#### **END OF ADDENDUM NUMBER TWO (2)**

CLINTON PARKS - PHASE I  
CITY OF CLINTON  
TRACEWAY PARKS & KIDS TOWNE PARK

TOWNE PARK BASE  
BID HARDSCAPE  
DETAILS

CCD PROJECT 23043.10

**1 TOWNE PARK BASE BID HARDSCAPE PLAN**  
 Scale: 1" = 20'

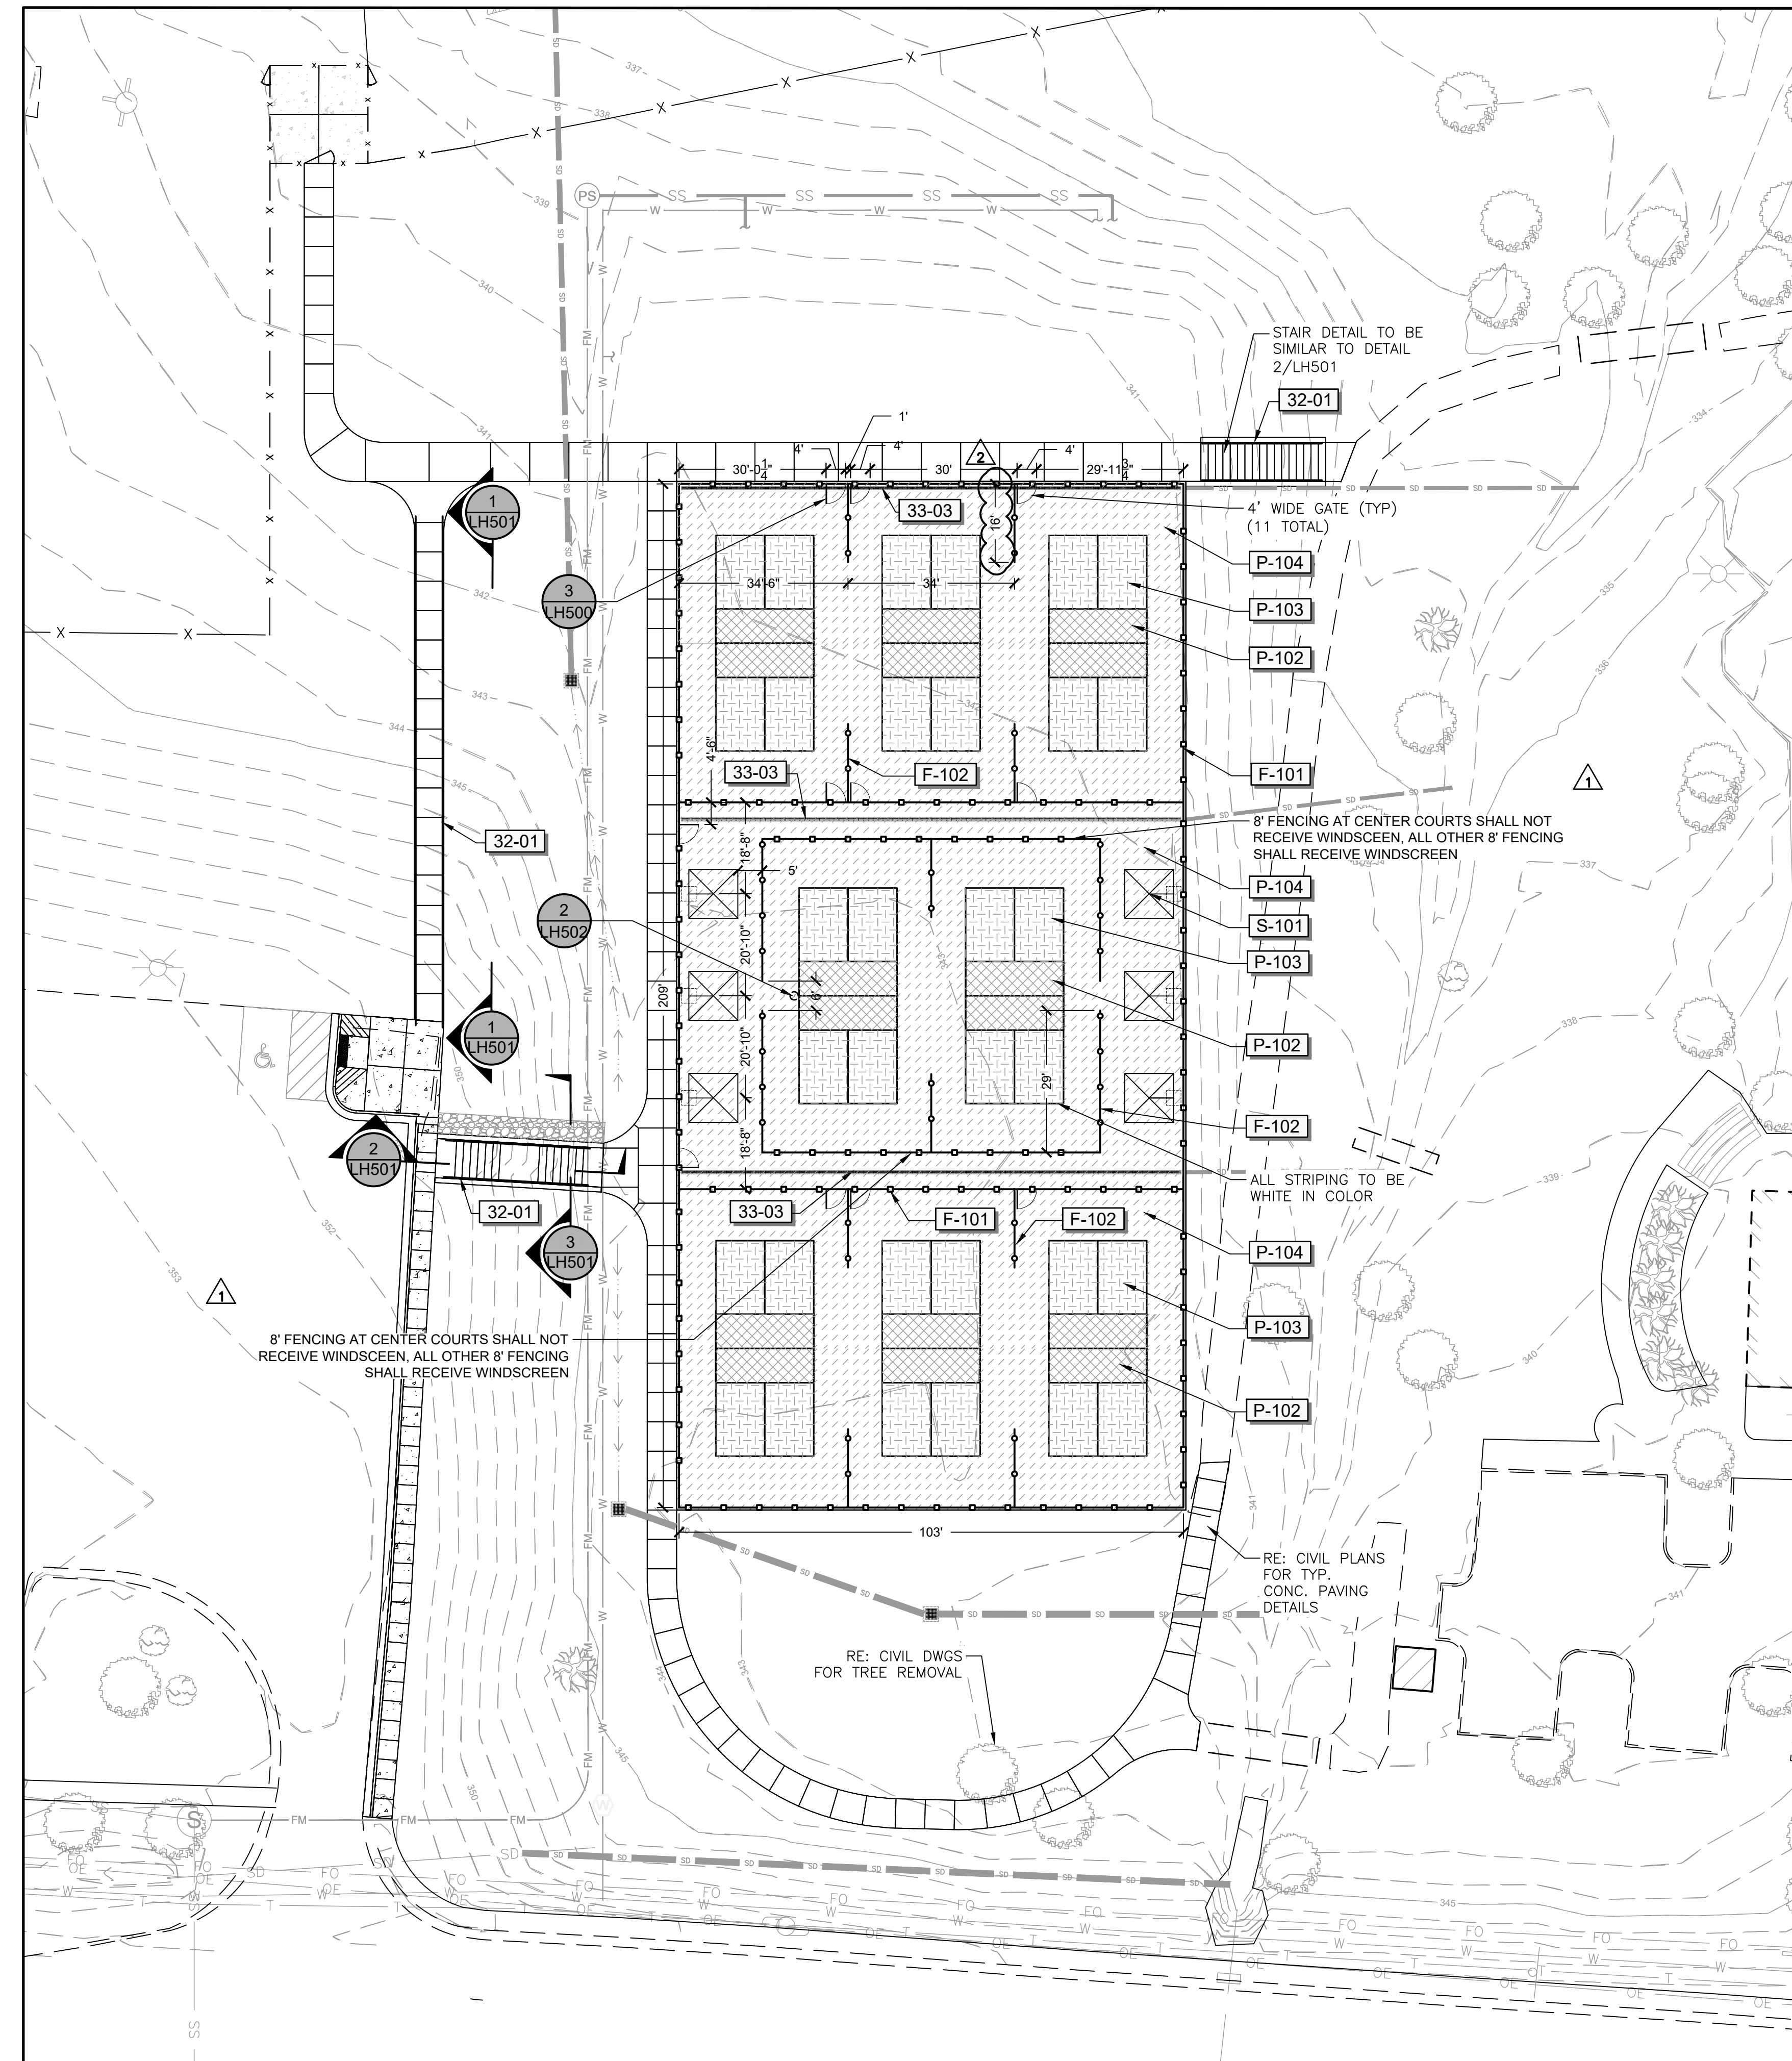
9. **DRAWING LH100 R1, TOWNE PARK BASE BID HARDSCAPE PLAN** – Replace with attached LH100 R2 dated as revised August 30, 2024.
10. **DRAWING LH500, TOWNE PARK BASE BID HARDSCAPE DETAILS** – Replace with attached LH500 R1 dated as revised August 30, 2024.
11. **DRAWING E5, POWER CONNECTION SCHEDULE – (ADD ALTERNATE #2)** – Add Mark as follows:
